Product / Process Change Notification (PCN)

PCN #: PCN_UtRJ45LAN_20200807
Affected Series: WE-UtRJ45LAN; 7499xxx; S1xxx
PCN Date: May 07, 2020
Effective Date: August 07, 2020

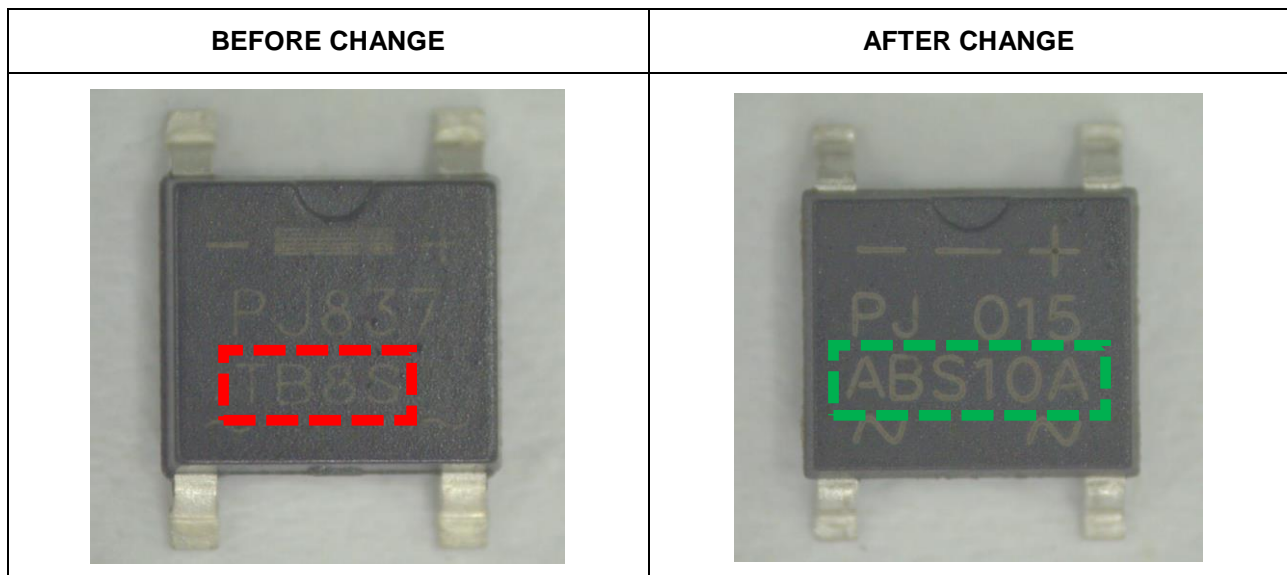
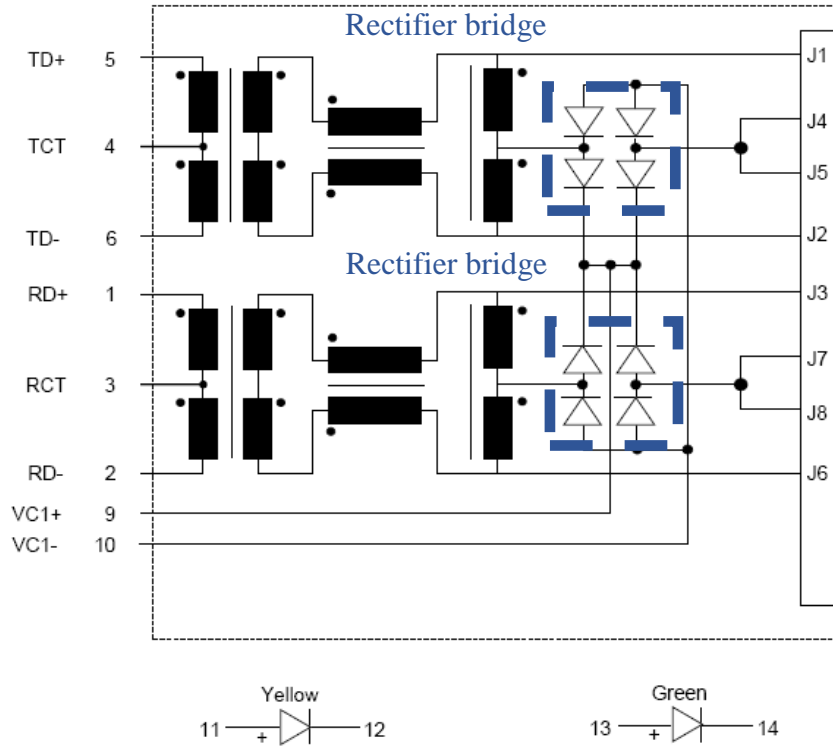
The rectifier bridge will be changed from TB8S to ABS10A with same characteristics. It is a sub component of the RJ45 as you can see in the following schematic of 7499210121A:
